April 29, 2014

RE: 550 Hubbel Way

Following the last review letter, I met with staff and the applicant to discuss the concerns. This submittal is their response to staff input. My comments and recommendations are as follows:

Concerns and Recommendations

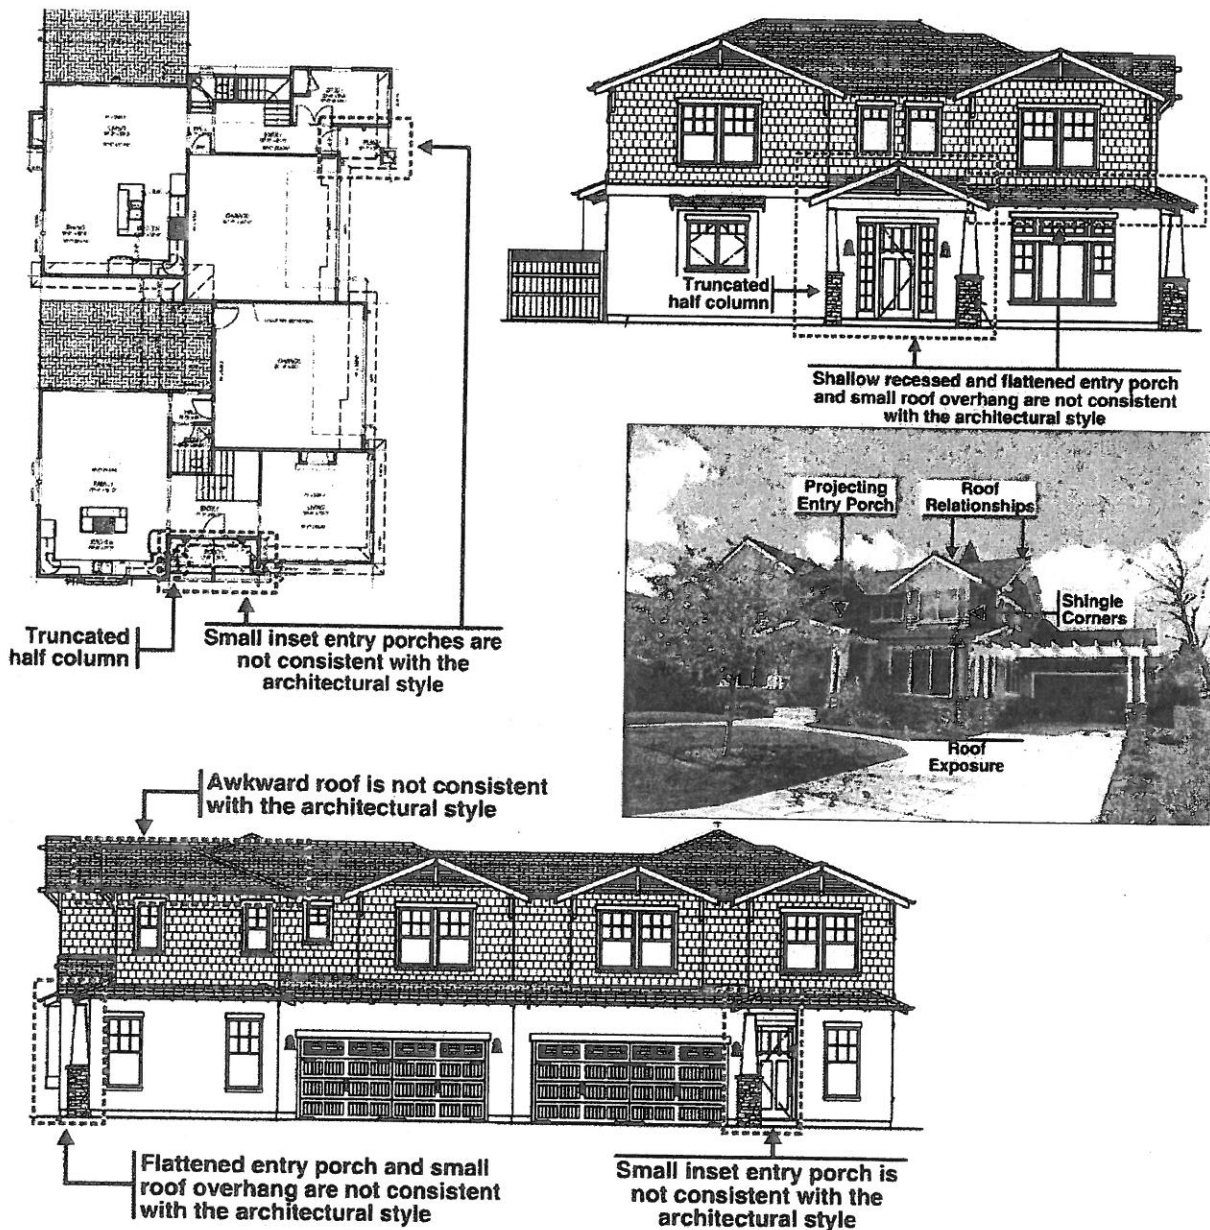
I previously reviewed another four unit plan for this site a little over one year ago. This revised site plan seems to work much better in terms of relating all four units more strongly to the street frontage, and in presenting a cohesive project.

There were, however, a few issues with the previous submittal in March that I found troubling. Overall, the concern was that a set of floor plans were worked out, and then a set of Craftsman Style details grafted onto the structures. The specific concerns which staff recently discussed with the applicant and his architect included the following:

1. The porches facing the street were very small, and recessed into the building form very much unlike the typical Craftsman Style entry.
2. The entries to the rear two units also were small, recessed entry porches which is not consistent with the architectural style.
3. The roof exposure at the second floor line on the street elevations at the auto court entry seemed too small.
4. The top roof adjacent to the auto court entry was very awkward, and not consistent with the architectural style.

The proposed design had a gable end facing the street and a very close hip end to the north.

PORCH: Previous Submittal

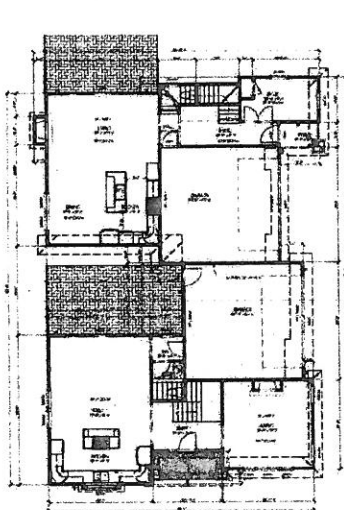
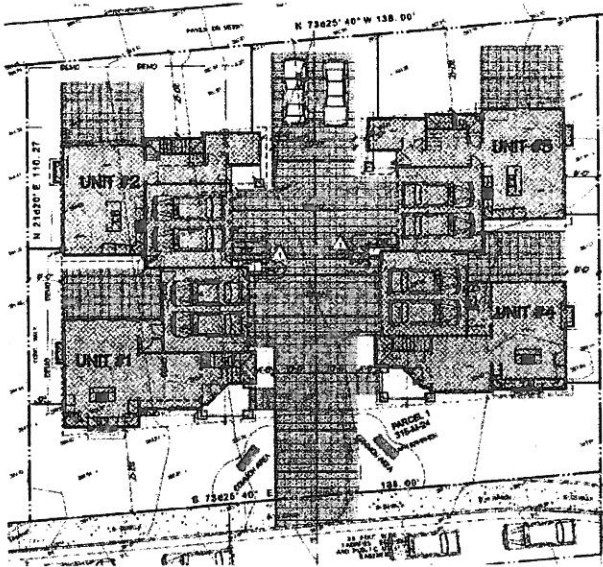
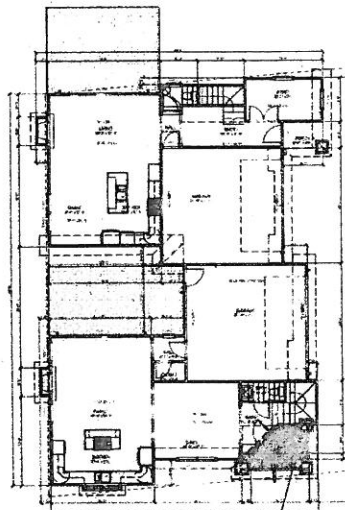
The applicant has responded to the recommendations in the review letter and our subsequent meeting by making the following changes:

1. Adding a textured, modular paving material for the entire auto court.
2. Increasing the size of the porches, and relocating them to a location adjacent to the auto court.
3. Improving the awkward corner massing and roof conditions at the second floor adjacent to the auto court.

These changes are shown on the new drawings shown below.

My feeling is that the project has been substantially improved from that submitted in March. I am comfortable with the rear porches being smaller in size than the street-facing porches given the limitations in space necessitated by the attached townhouse product type and the dimensions of the site. However, I am still not convinced that the porches on the front units are meeting the word and spirit of the Town's Residential Design Guidelines 3.10.1 which calls for usable porches. The porch depth, while larger than first proposed, would seem to preclude porch furniture in a comfortable arrangement. And, I am rather uncomfortable with the angled wall at the entry door which encroaches on the available porch space. This arrangement is much less satisfactory than the similar project example in San Mateo shown the applicant at our meeting (see photo below).

Staff and the Planning Commission may wish to discuss this further with the applicant before deciding on the acceptability of the plans presented. Other than that issue, I have no recommendations for changes.
